**ADDENDUM  
NO. 3**

**September 30, 2025**

**VALE FACILITY ADDITION/RENOVATIONS AND  
MAINTENANCE/IT FACILITY PROJECTS**

**Addendum Three (AD.03)** to the drawings and specifications prepared by Gibraltar Design for **Valparaiso Vale Facility Addition/Renovations and Maintenance/It Facility and Related Work** for Valparaiso Community Schools, Valparaiso, Indiana.

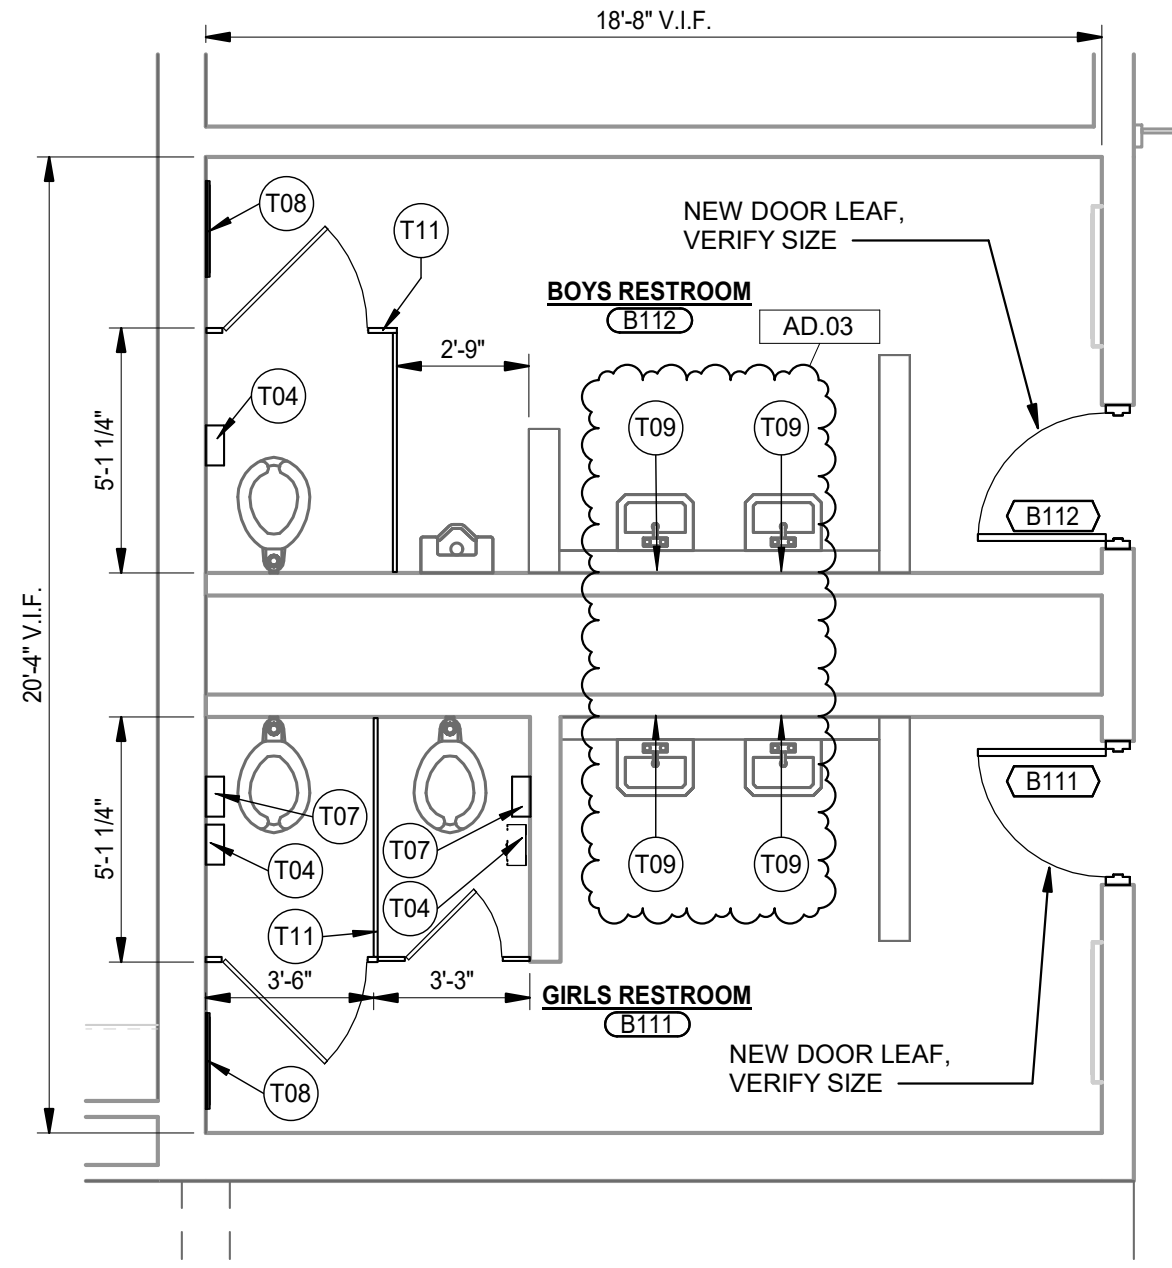
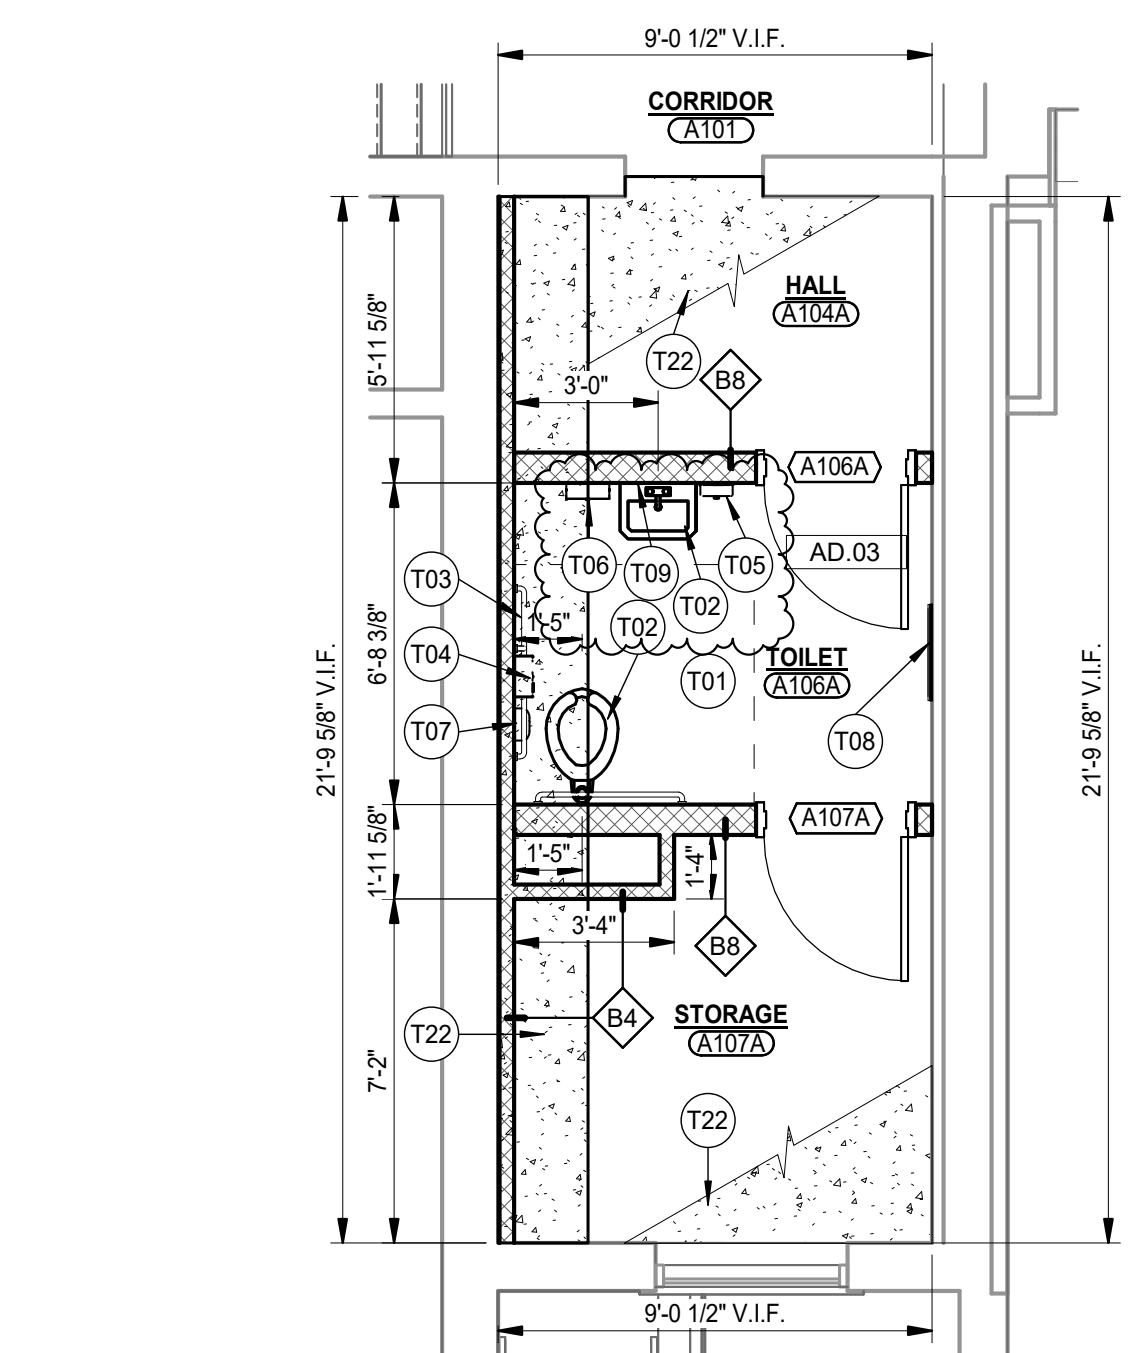
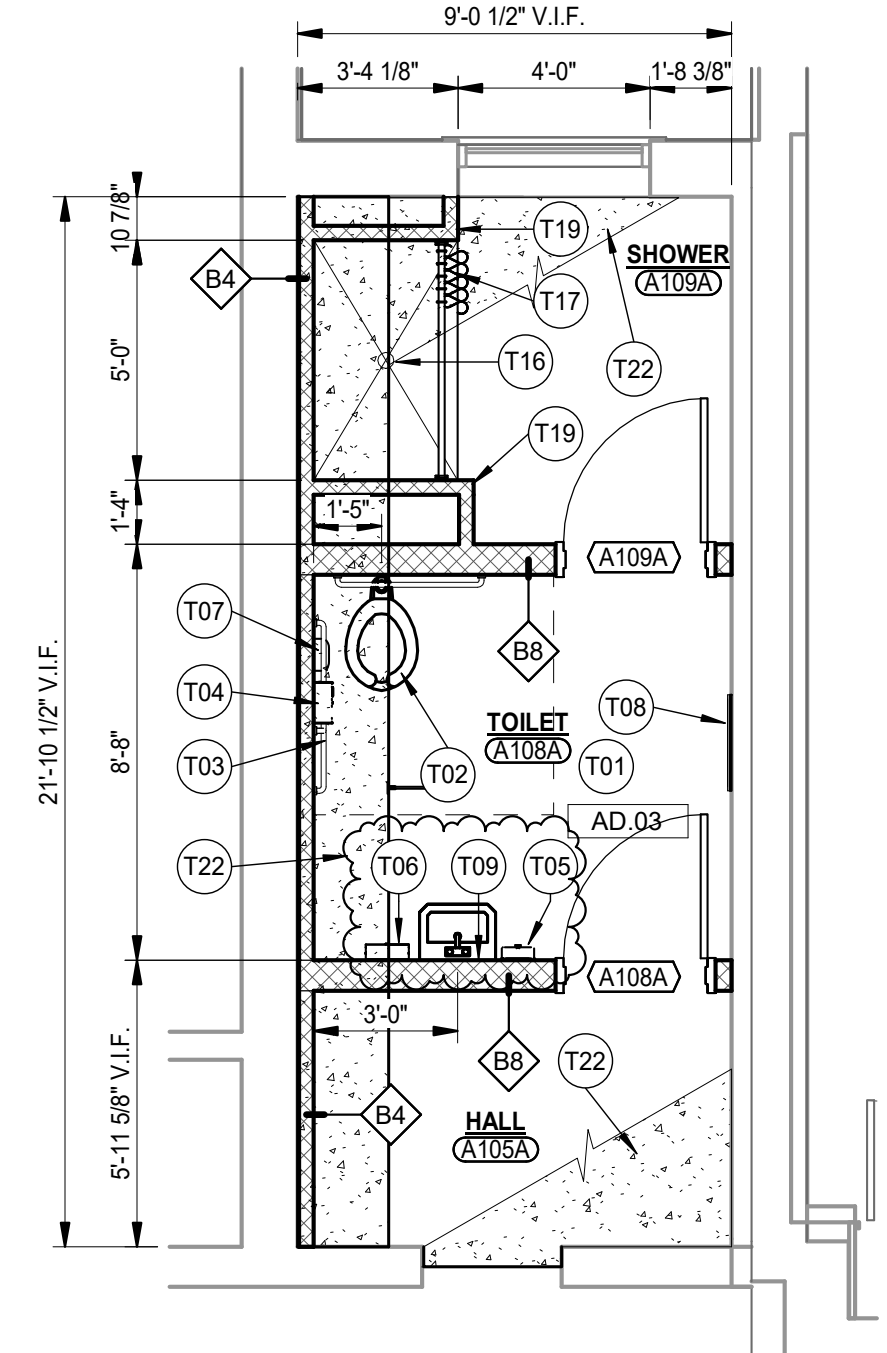
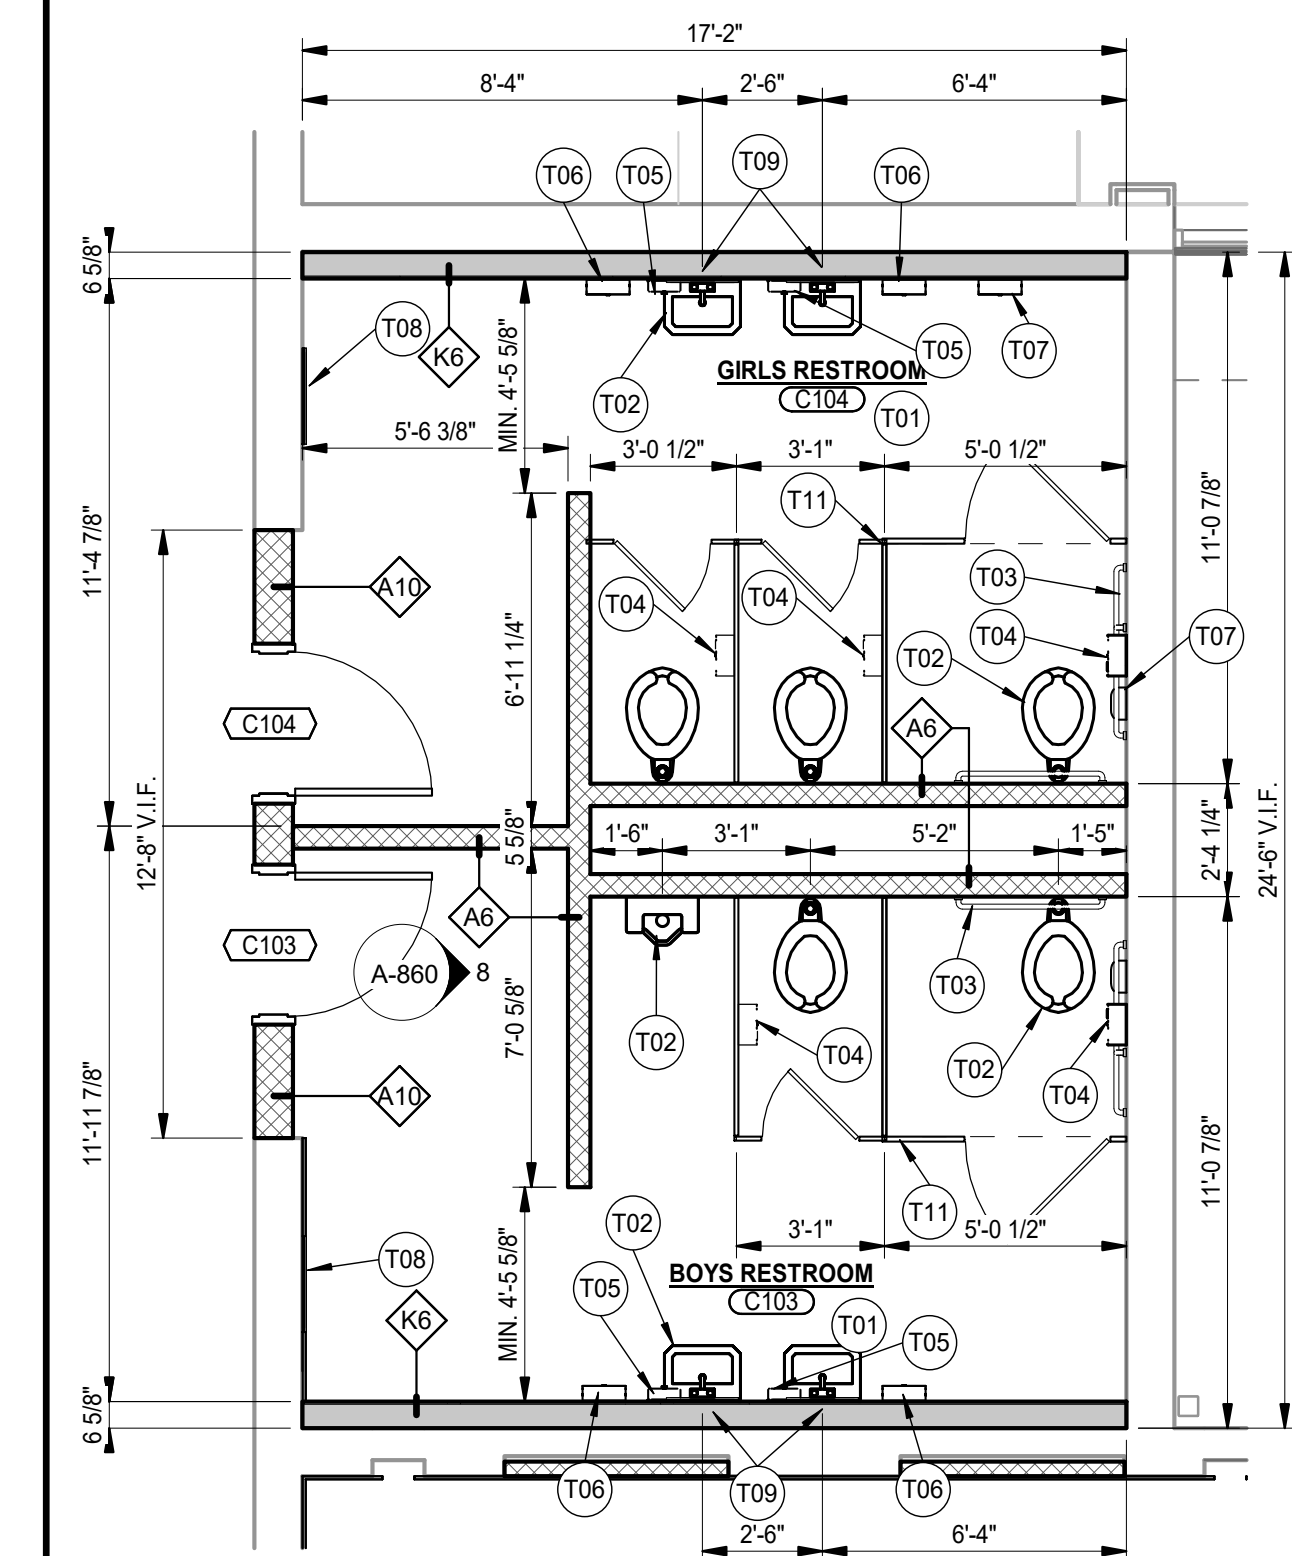
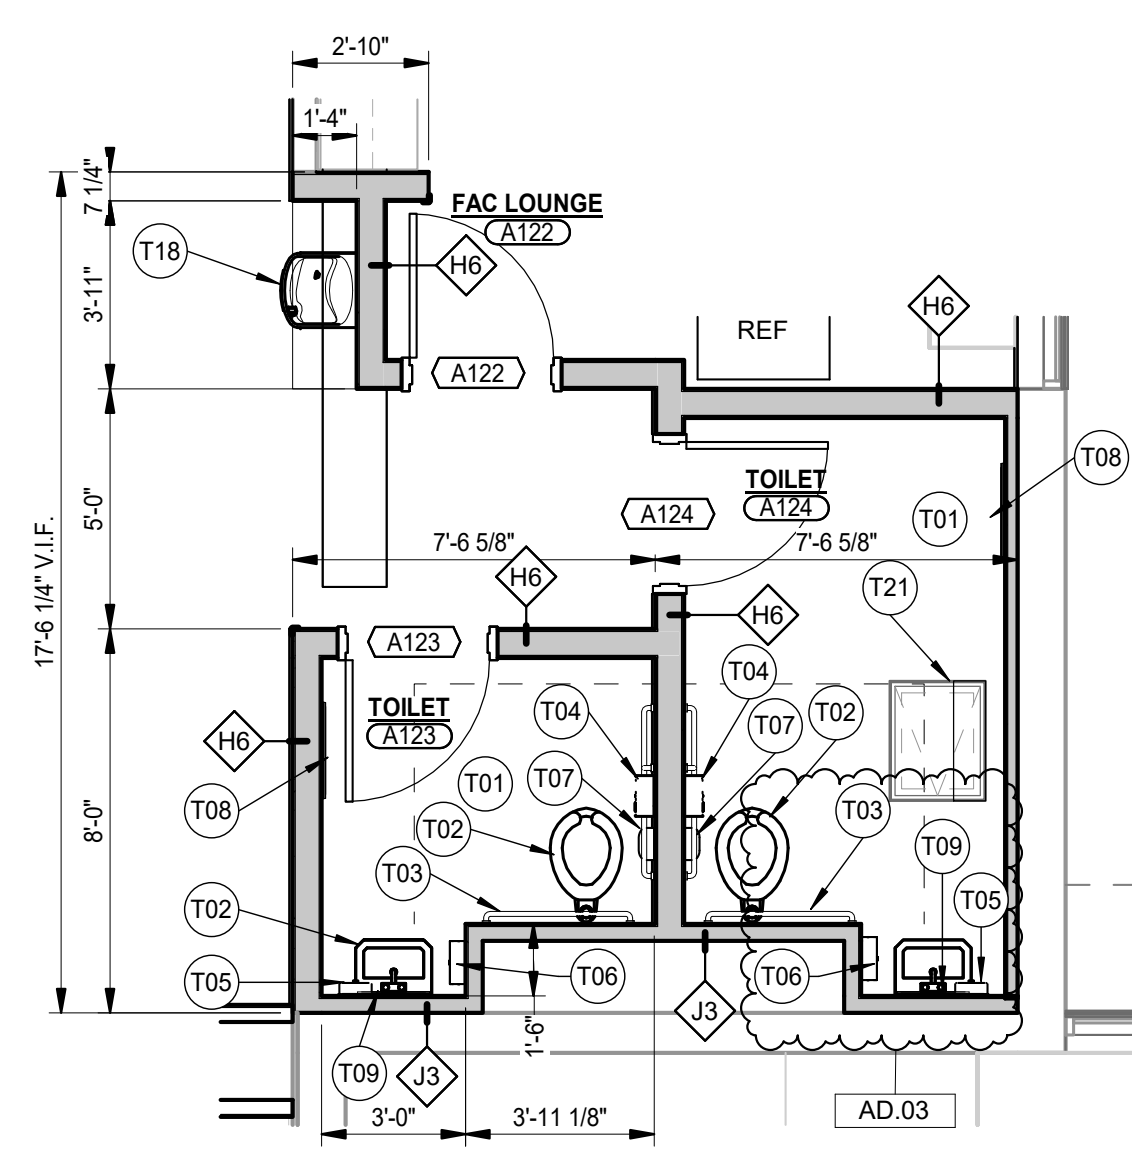
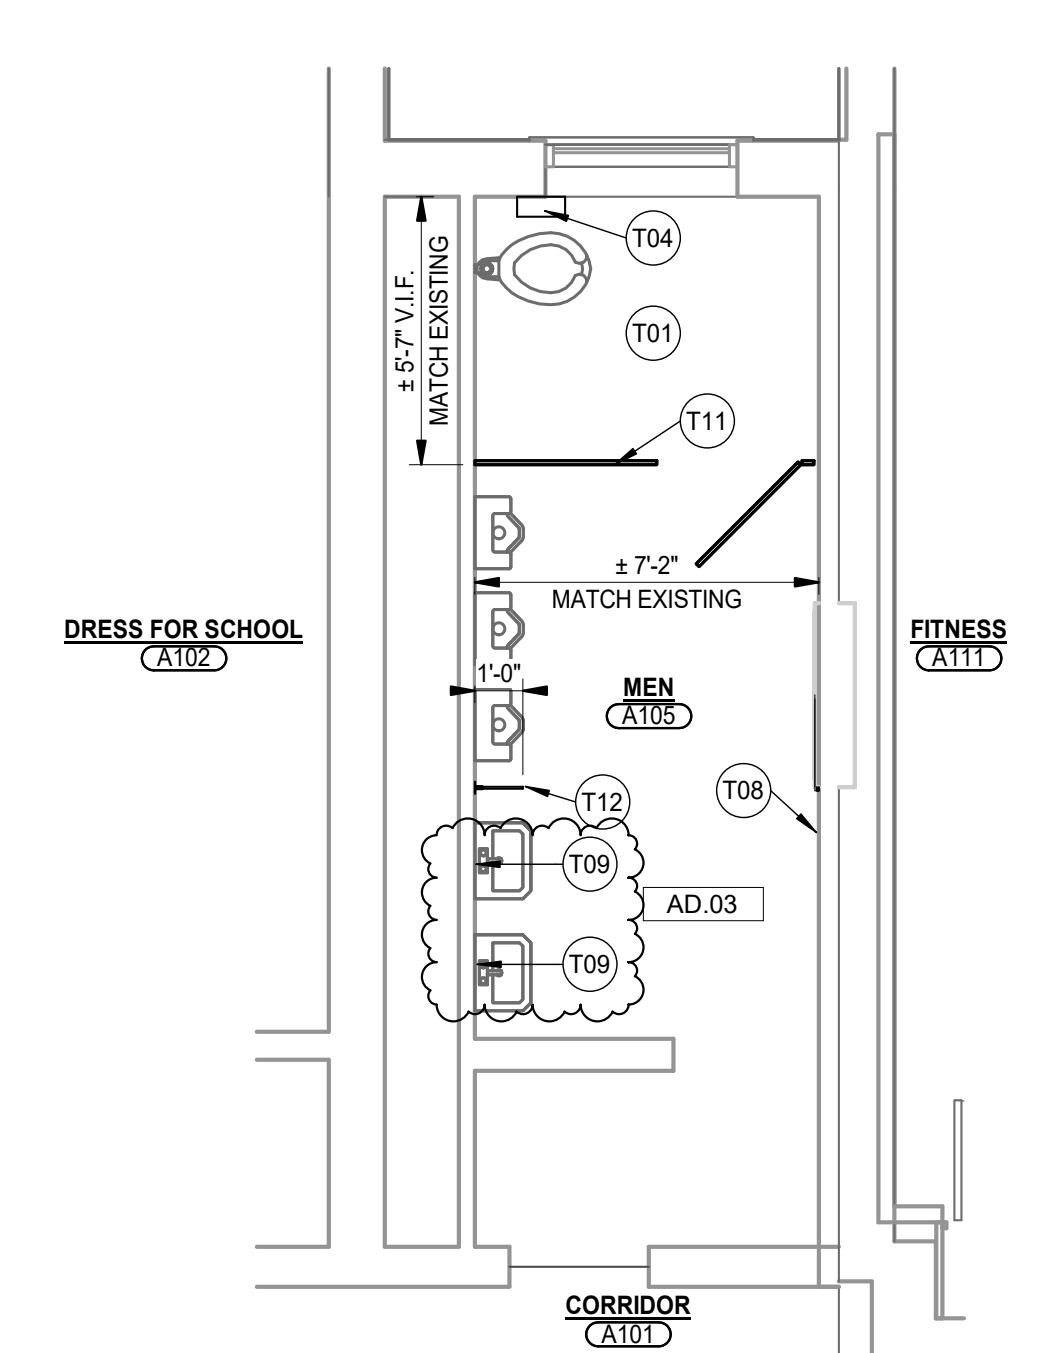
- A. Refer to revised, full-size drawing, included in this Addendum, for revisions.
  1. Added T5, T6, T7 and T9 to several enlarged plans.
